## **Aberdeen Cycle Forum**

### **Response to Third Don Crossing Proposal**

#### **October 2004**

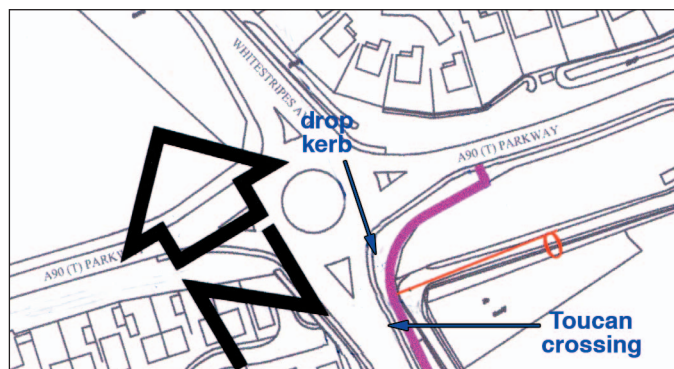
For the section of the proposed route through to the St Machar Drive section, a segregated facility on its own is considered inadequate, and the Forum would not support a proposal that did not also include the suggested on-road cycle facility. The primary problems that the segregated facility on its own presents are:

- a. Problems of access at both ends of the route for cyclists travelling in both directions.
- b. Problems accessing housing and routes to the south / west.
- c. Whilst an off-road route is good at attracting new cyclists, usage typically drops off as cyclists become more experienced.
- d. Off-road routes are most suited to leisure cyclists (who will go where the route goes), but do not serve utility cyclists as well (who may only use a part of the route).
- e. Off-road cycle lanes undermine the on-road rights that cyclists have, creating a more antagonistic and dangerous cycling environment. Anecdotal evidence suggests this is already a significant problem on several routes in Aberdeen.

##### Junction With Parkway

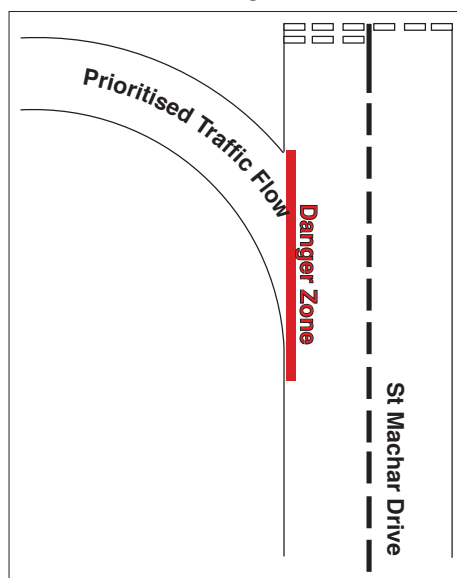
Toucan crossing is needed just south of the roundabout junction with the Parkway to facilitate cyclists on the off-road facility turning left on the Parkway, and to facilitate on-road cyclists who wish to avoid the roundabout turning right on the Parkway. This could also aid cyclists travelling east to west on the Parkway who wish to avoid the roundabout. A drop curb should be added to aid access to the off-road facility for cyclists coming from the north and west around the roundabout.

#### Junction With St Machar Drive

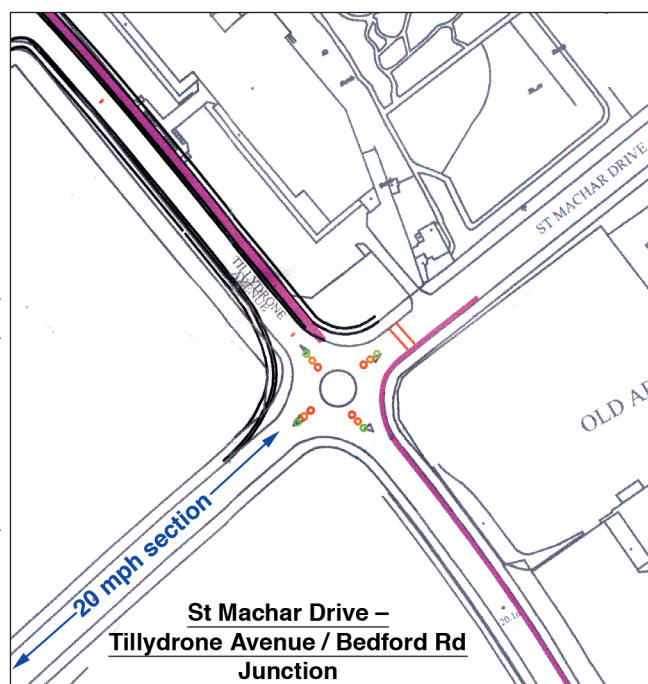
This is considered by the forum to be the critical part of the cycle infrastructure associated with the Third Don Crossing proposal, presenting a point of real danger for cyclists.

It is our understanding that the intention is to prioritise traffic flow along the Tillydrone Avenue – St Machar Drive (south) corridor, with a triangular island being used to separate traffic travelling north along this corridor from traffic wishing to continue across the junction or turn right onto Bedford Road.

From the perspective of a cyclist travelling northwards on St Machar Drive, this junction design is only safe when staying with the flow of prioritised traffic, turning left on to the on-road cycle lane we have suggested on Tillydrone Avenue. Using this lane the cyclist can continue on-road, or use the first Toucan crossing to obtain safe access to the off-road facility. Cyclists wishing to go straight on, or turn right at this junction (routes feeding the University and adjacent residential areas) are presented with the prospect of crossing the prioritised flow of traffic (see diagram left).

We cannot at this time devise a safe and cycle-friendly solution for this junction. The Forum feels that there is a need to consult further with the design team to see if this can be achieved. Making this section of St Machar Drive a 20 mph zone, and extending the zone past St Machar Academy, is seen as an essential measure to mitigate the dangers that this junction presents. We also feel this measure is essential for a road that passes the main exit from a large School, and would be needed to enable a 'Safe Route to School' to be instigated.

One aspect of the design of this junction that presents particular concern is the positioning of the triangular island. This is considered most dangerous if it protrudes out in to the straight-on edge of St Machar Drive, as this would force cyclists going straight on to move out whilst simultaneously negotiating the crossing of the prioritised traffic flow. The preferred position for this island is shown in the diagram above.
